A G E N D A
LOCAL PLANNING AGENCY / PLANNING ADVISORY BOARD
TO BE HELD NOVEMBER 4, 2021
AT 5:30 PM
121 SW FLAGLER AVENUE, STUART FL 34994
121 S.W. FLAGLER AVE. STUART, FLORIDA 34994

1. SILVERTHORN RPUD - FIRST READING (QUASI-JUDICIAL)(RC):

Staff Review
October 24, 2021

MATCH LINE B (SEE SHEET 5)

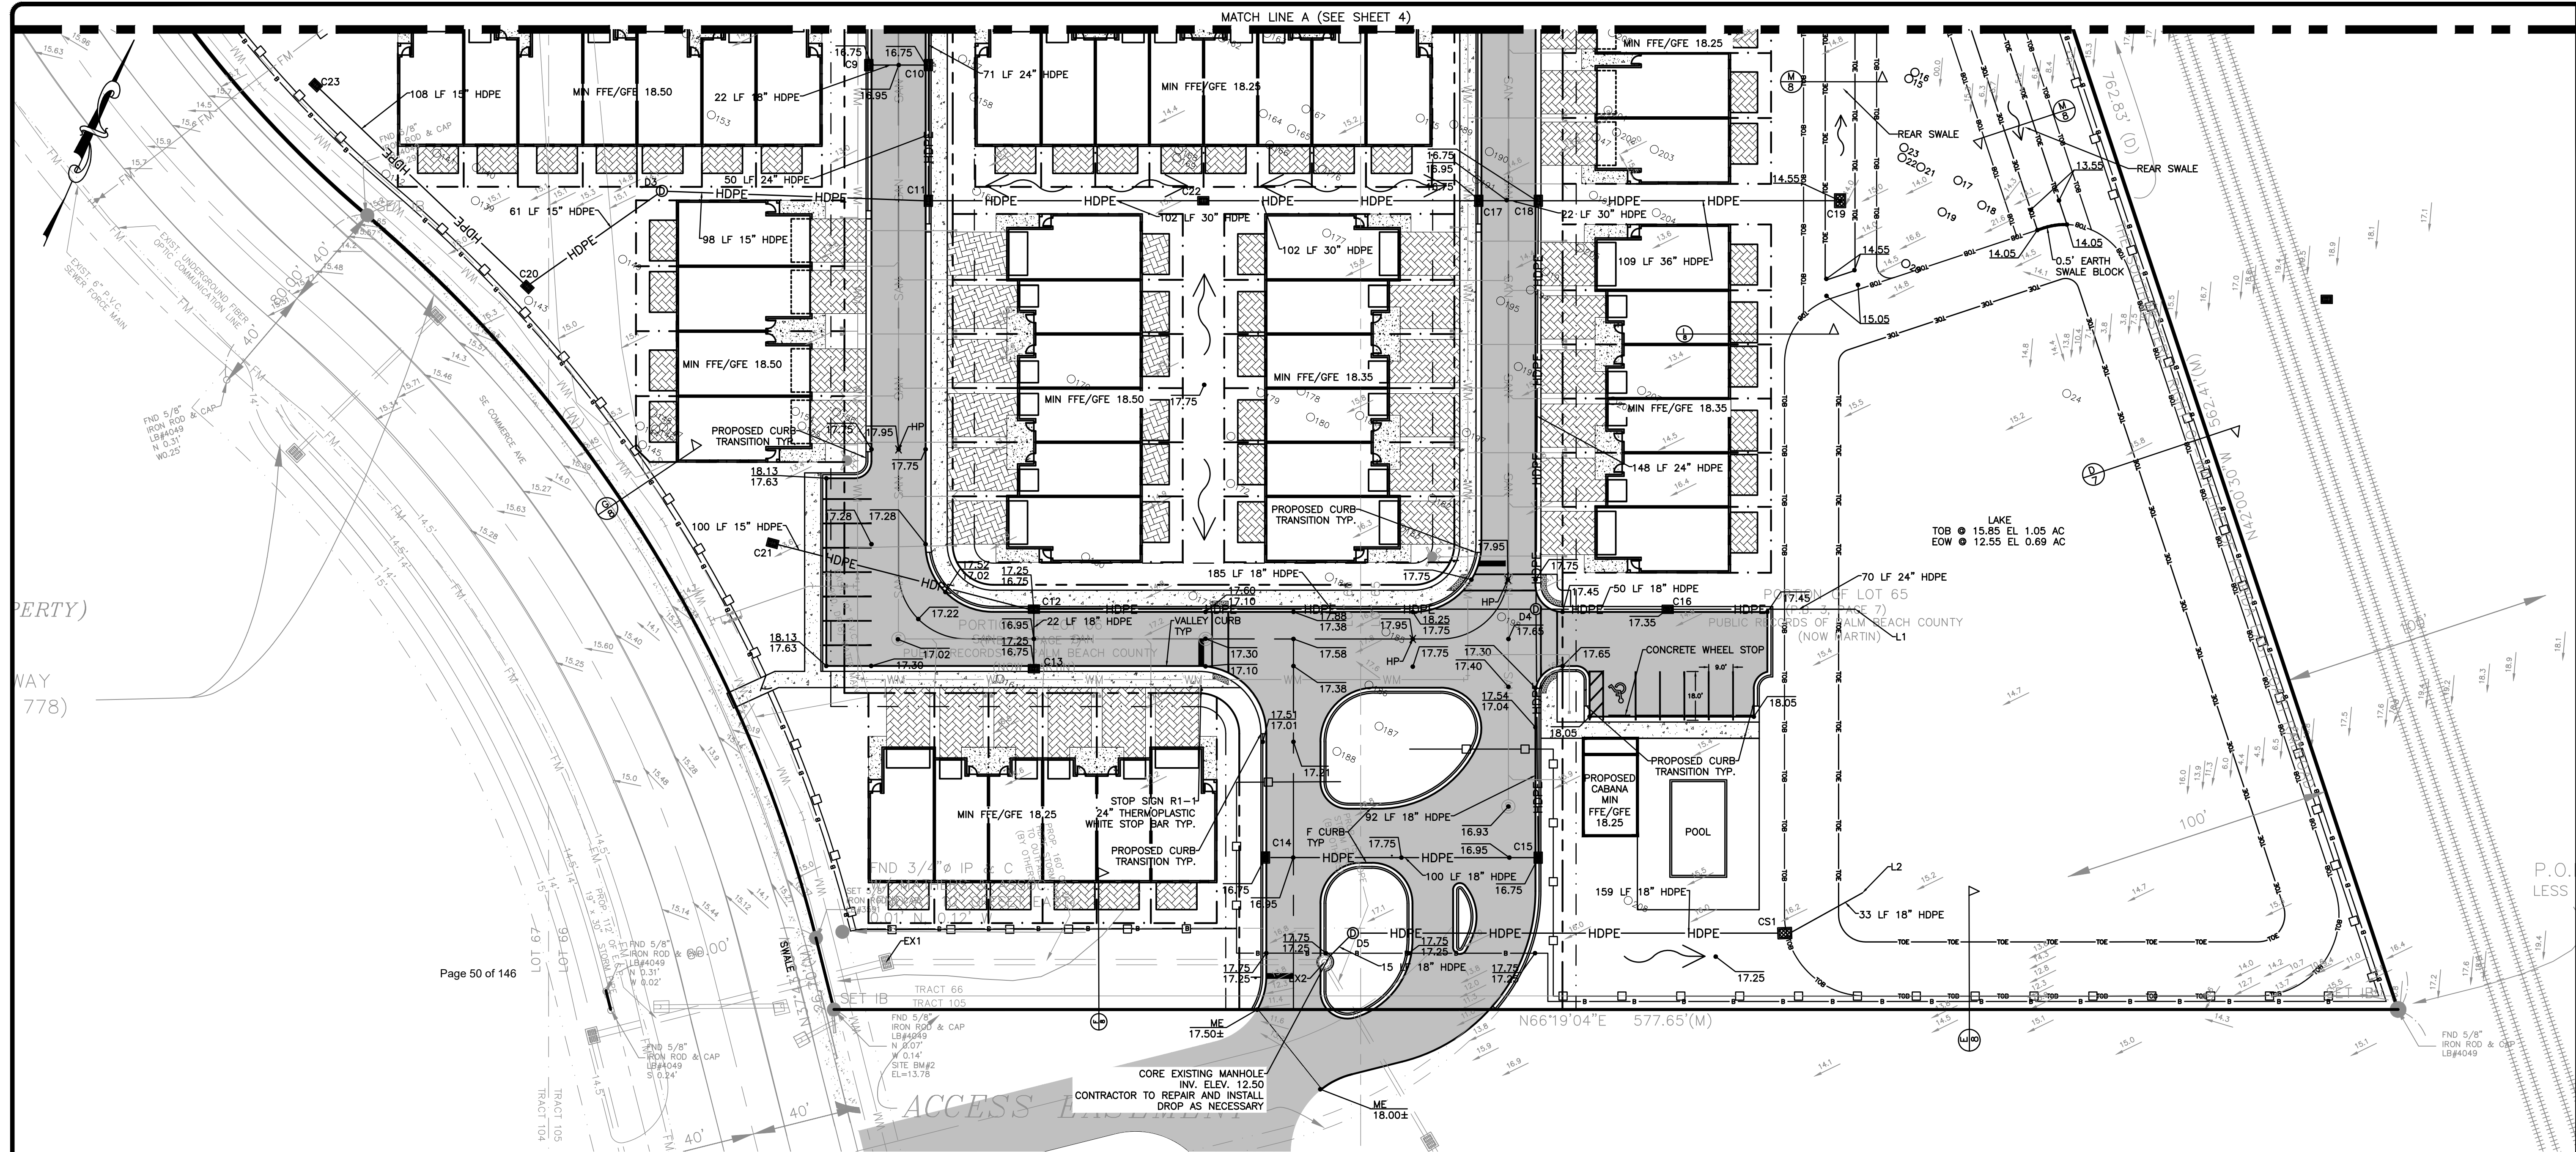
Sheet 3 – revise silt fence to account for the offsite commercial property that discharges on to the site at the NE corner

Sheet 4 – Provide a cross section along the NE property adjacent to the west side of the commercial property. It appears this area flows on to the site as well but is not clear how the inflow is being routed.

Sheet 4 – In this same area where cross section B/7 is provided, the perimeter berm will extend into the commercial property. What is the elevation of their lift station and does the rim of it need to be adjusted?

1. Sheet 3 – revise silt fence to account for the offsite commercial property that discharges on to the site at the NE corner.
Acknowledged, the silt fence around a portion of the commercial area has been removed to allow runoff to continue to enter the site. Please see the revised plans.

2. Sheet 4 – Provide a cross section along the NE property adjacent to the west side of the commercial property. It appears this area flows on to the site as well but is not clear how the inflow is being routed.
Acknowledged, Section J has been added. Existing elevations near the rear of the Commercial area are higher than the proposed Silverthorne berm, flow in these areas will continue to flow onto the Silverthorne site. Runoff further north where elevations drop will remain on the Commercial area property. Please note, per the Stuart Business Park master drainage plan and Environmental Resource Permit, the commercial parcel is not permitted to discharge to the SBP master drainage system. Please see the revised plans, the enclosed SBP Environmental Resource Permit, and the enclosed SBP Master Drainage Map.

3. Sheet 4 – In this same area where cross section B/7 is provided, the perimeter berm will extend into the commercial property. What is the elevation of their lift station and does the rim of it need to be adjusted?
The rim is at elevation 17.50 NAVD, above the proposed perimeter berm elevation. Please see the revised survey.
